Location of Construction: 522 Congress St		Owner: Maine College of Art		Phone:		Permit No: 950053	
Owner Address:		Leasee/Buyer's Name:		Phone:		Business Name:	
Contractor Name: F.W. Cunningham P.O. Box 1140		Address: Portland, ME 04101 Attn: Clarence Blanchard		Phone: 772-4299		Permit Issued: JAN 25 1995	
Past Use: Mix Use		Proposed Use: Same		COST OF WORK: \$ 3,540,000.		PERMIT FEE: \$ 17,720.00	
Proposed Project Description: Make renovations as per plans		FIRE DEPT. <input type="checkbox"/> Approved <input type="checkbox"/> Denied		INSPECTION: Use Group: [handwritten] Type: [handwritten]		Zone: CBL: 037-H-006	
				Signature: [handwritten]		Signature: [handwritten]	
Permit Taken By: Mary Gresik		Date Applied For: 6 January 95		PEDESTRIAN ACTIVITIES DISTRICT (P.A.D.) Action: <input type="checkbox"/> Approved <input type="checkbox"/> Approved with Conditions <input type="checkbox"/> Denied		Zoning Approval: Special Zone or Reviews: <input type="checkbox"/> Shoreland <input type="checkbox"/> Wetland <input type="checkbox"/> Flood Zone <input type="checkbox"/> Subdivision <input checked="" type="checkbox"/> Site Plan maj <input type="checkbox"/> minor <input type="checkbox"/> mm <inp

Lower Level
4/12/95

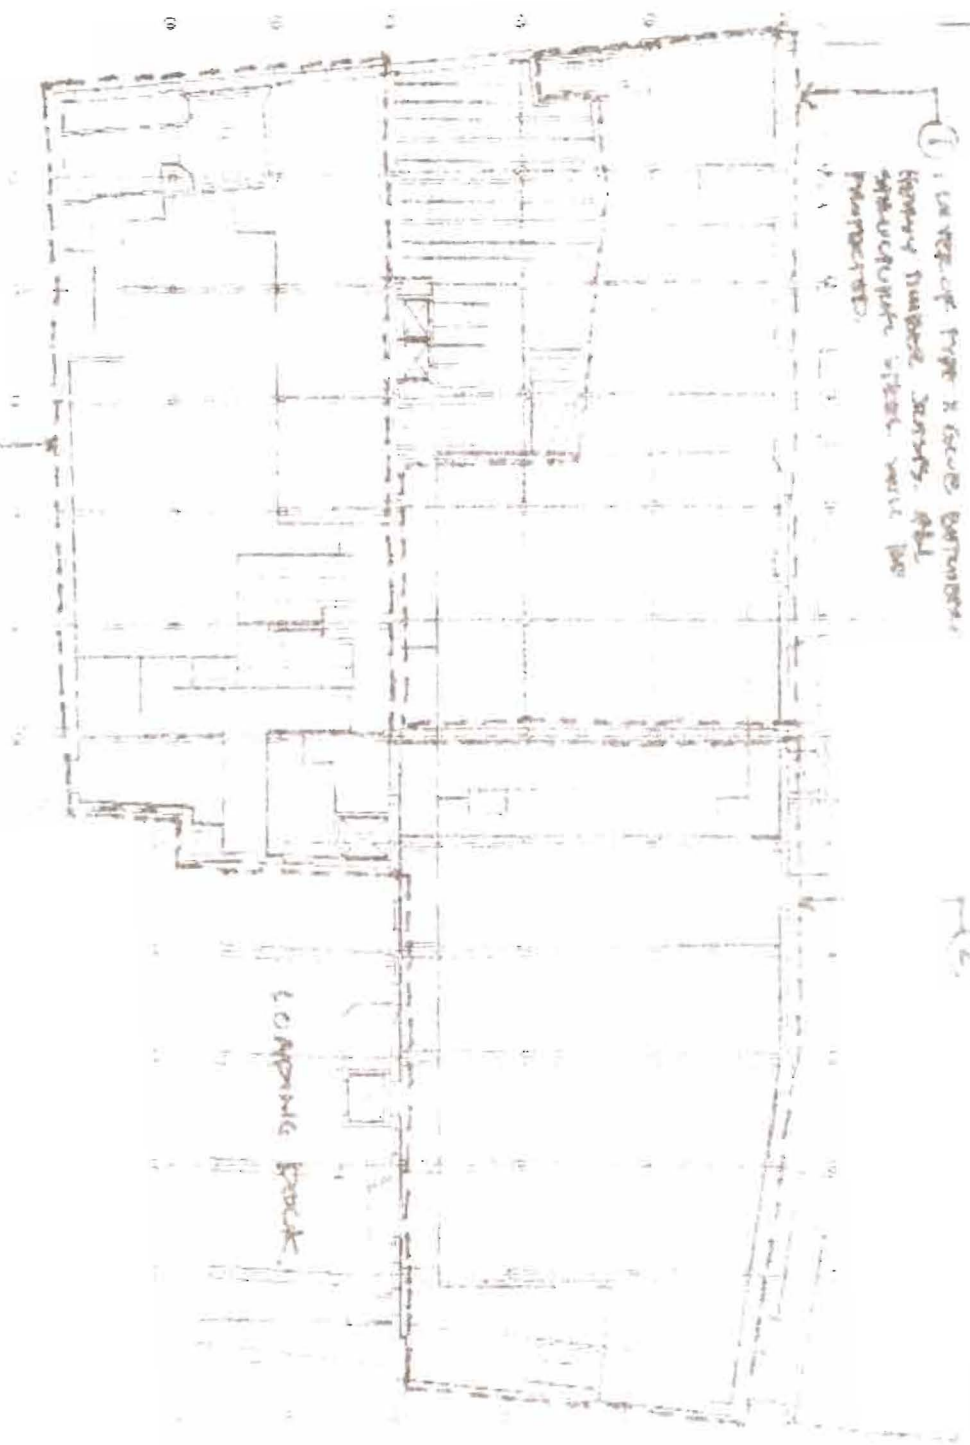
(1) Use ref-up type & secure bathroom
 Heavy timber doors, all
 structural steel work
 protected

(2) Existing left of present plan
 No further protection required
 provide all interpretations

1st floor
 9/12/47

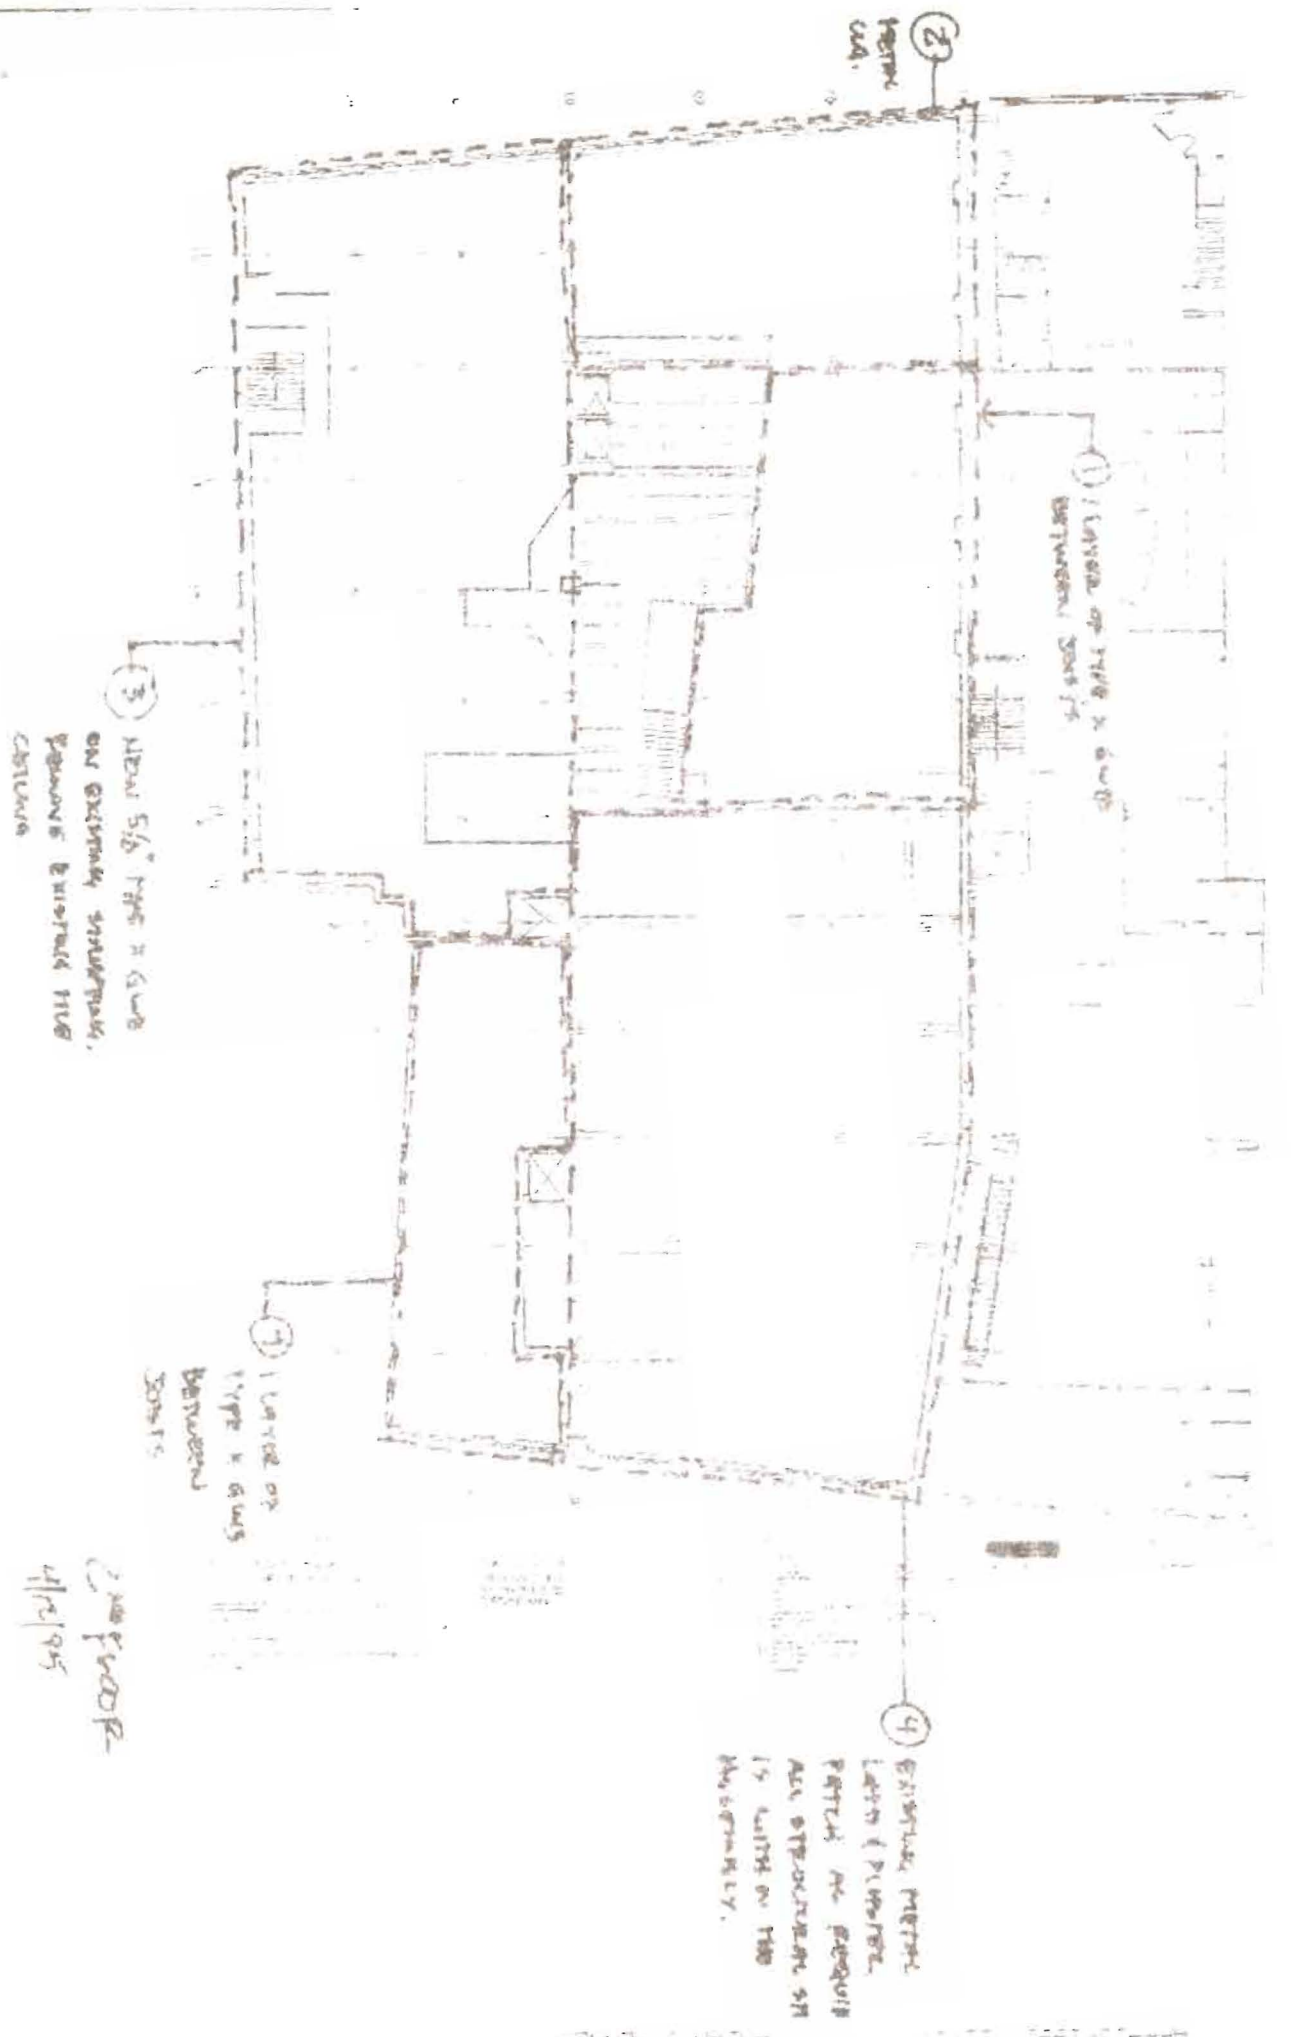
① 1 layer of type x studs
between joists

② between
wall

③ About 5/8" type x studs
on exterior structure,
REMOVE BRICKED TUB
CHIMNEY

④ 1 layer of
type x studs
between
joists

④ Existing interior
LATH & PLASTER
PARTIAL ON PERIMETER
ALL STRUCTURE IN
IS WITH IN THE
PERIMETER.
